Technical Bulletin

DP02	TB0003-2006	Elan Motorsports Technologies	
From:	Chip Lewis		
Subject:	Alternator Belt Idler Pulley	Date:	September 14th, 2006

Picture 1 - Front Cover (Corner Ground)

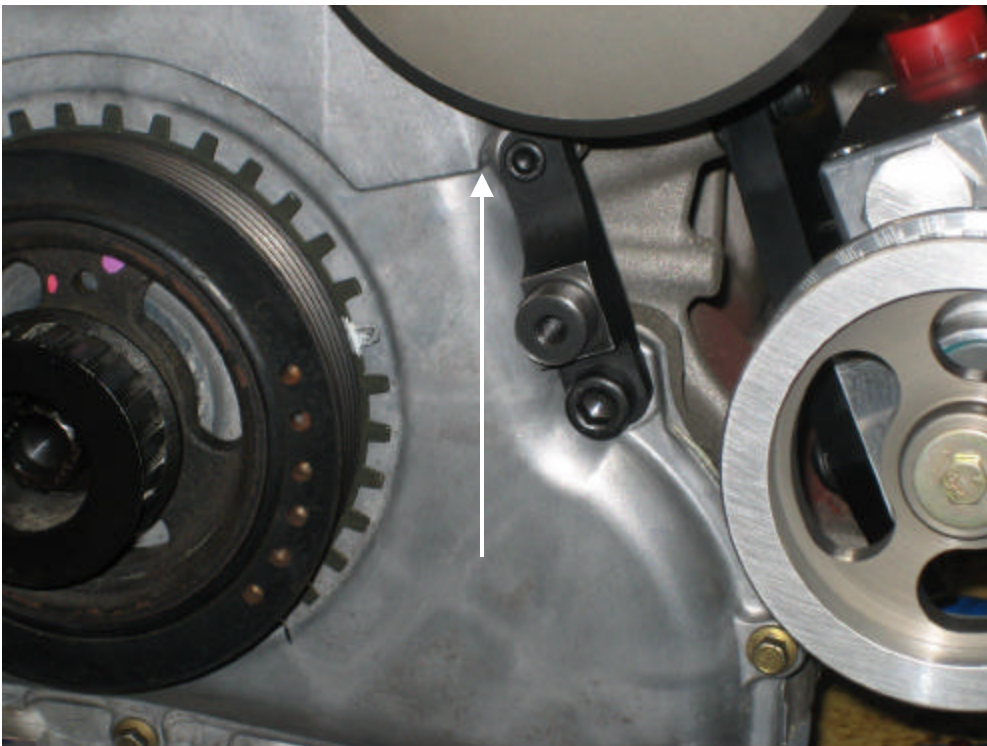
- 1) Once the front of the engine is accessible, you must remove the oil pump belt and the alternator belt.
- 2) The two lower bolts in the below picture must be removed, and the corner above them ground away, slightly (Shown in Picture #1). Do not remove front cover to grind corner.

Picture 3 - Pulley Installed with Belt

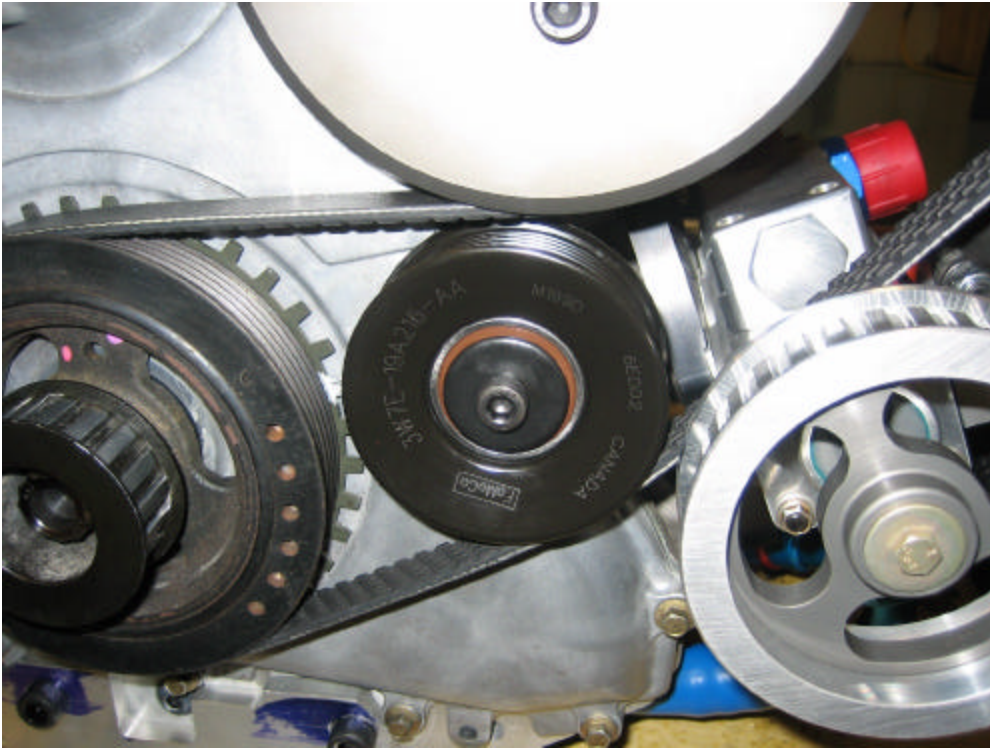
- 5) The alternator belt should be re-installed so that it runs as before, with the exception that it runs underneath the new pulley (Shown in Picture #3).
